Entergy Operations, Inc.
1448 S.R. 333
Russellville, AR 72802
Tel 479-858-4710

1CAN041404

SUBJECT: Responses to RAIs Regarding 1R24 Steam Generator
Tube Inspection Report
Arkansas Nuclear One, Unit 1
Docket No. 50-313
License No. DPR-51

**Responses to RAIs Regarding 1R24 Steam Generator
Tube Inspection Report**

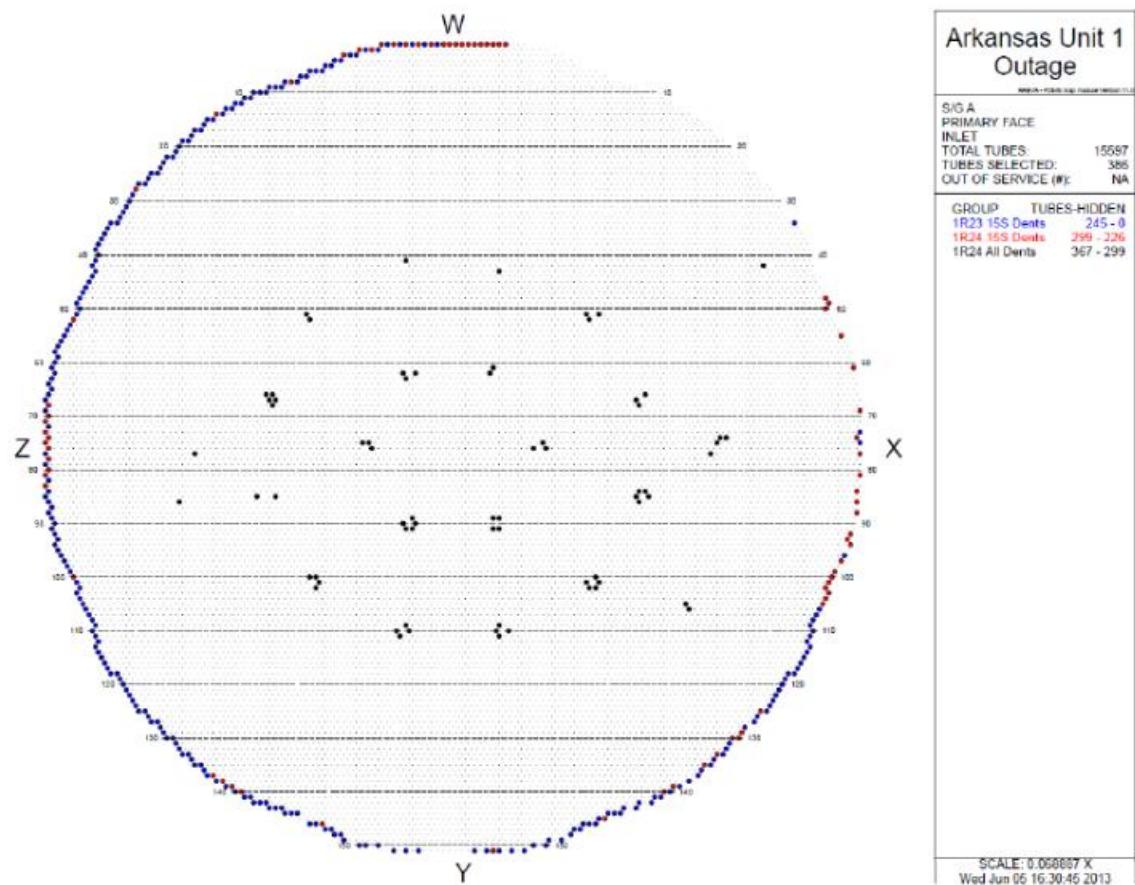
- 3. As discussed in the telephone call on July 9, 2013 (ADAMS Accession No. ML 13172A029), peripheral tubes were inspected for signs of denting to assist in identifying locations where the tube support plates are suspected not to be freefloating. Please discuss the results of these inspections and your assessment of these results.**

The top tube support plate (15S) showed a slight circumferential progression in the periphery along the W and or X axis as shown in the plot (red indications are the new dents (DNTs) in 1R24). The progression was not as significant as seen in prior outages.

All voltages were below or near 1.0 Volts, and there was no noticeable difference in any repeat DNT voltage.

The circumferential extent of locking at the top TSP appears to be increasing with each operating cycle. The small dent analysis of the tubes in the 'drilled-only' holes of the top TSP are used to monitor this general progression of the overall mechanism associated with tie rod bowing. An increase in circumferential extent of locking may indicate that incremental load is being applied to the tie rods (with potential consequent increase in number of rods with bowing and/or increased magnitude of bowing). Of course, the as-inspected changes in tie rod bowing are the final measure of the progression of the postulated mechanism.
